**PROJECT SPECIFICATIONS AND SALES AGREEMENT**

NAME: **Alaine Lester Residence**  
 ADDRESS: **314 Del monte Dr Friendswood, Tx**  
 PHONE: [REDACTED]  
 EMAIL: [REDACTED]

## Swimming Pool Plan Review 2018 International Swimming Pool and Spa Code Apply

Address: 214 Del Monte

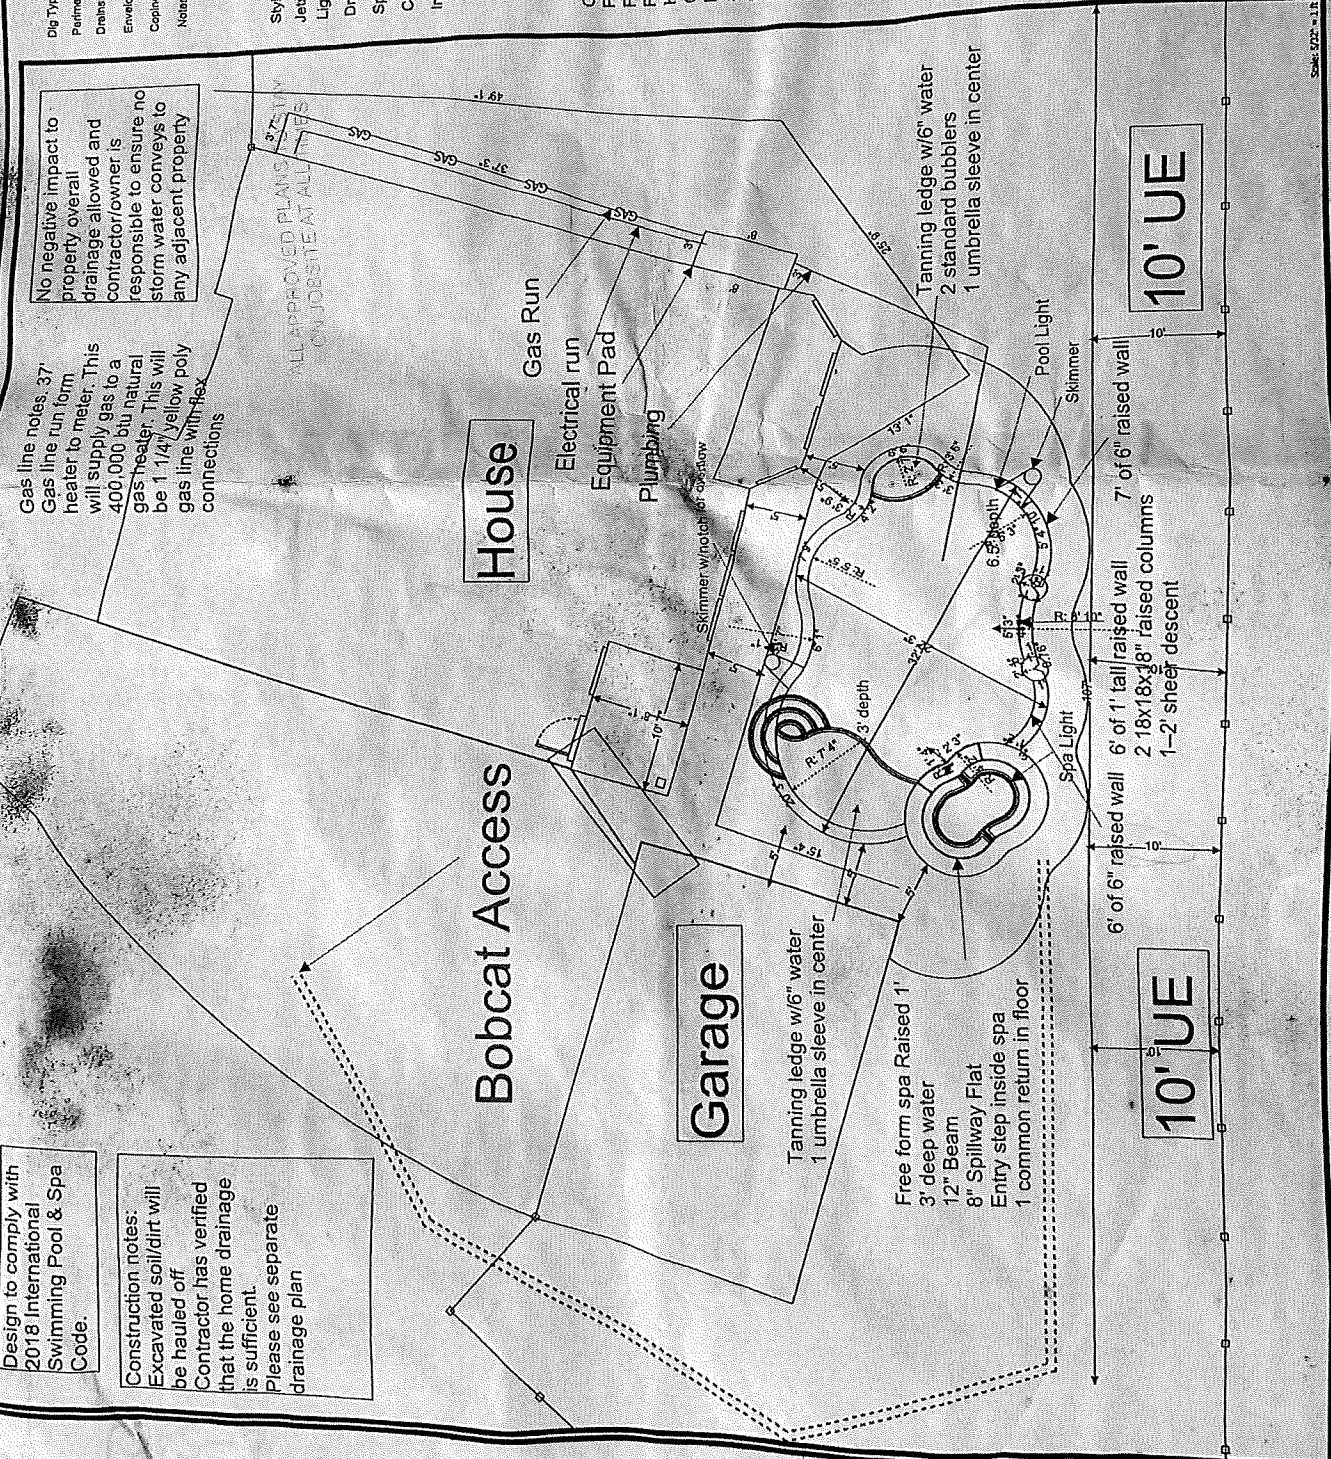
1. All doors with direct access to the pool area shall be equipped with an alarm which produces an audible warning when the door is opened. The alarm deactivation switch(s) shall be located at least 54 inches above the threshold of the door.

2. No portion of the pool will be allowed in the U.E. **This includes the plumbing and electrical.**
3. The waters edge of the pool cannot be within 5' of any structure unless a signed and stamped original letter from a Certified Engineer is attached.

4. All windows within 5 feet of pool must be meet Glazing and wet surfaces requirement listed in 2018 IRC R308.4.5.
5. **P-Traps** are required for ALL filters. Backflow Preventers for fill lines.

6. Pool heaters need to comply with manufactures specifications.
7. Main drains (pool and Spa) must be installed before steel inspection.
8. All steel must be capped or turned down, for safety.

9. Temporary fencing will need to stay up during construction.
10. No electrical receptacles can be within 6' of waters edge, and at least one is required. All receptacles within 6-20 feet of the pool must be GFCI protected.

11. Access gates shall open outward away from the pool and be self-closing and have a self-latching device.

Where the release mechanism shall be located less than 54 inches from the bottom of the gate, the release mechanism shall be located on the pool side of the gate a minimum of 3 inches below the top of the gate.
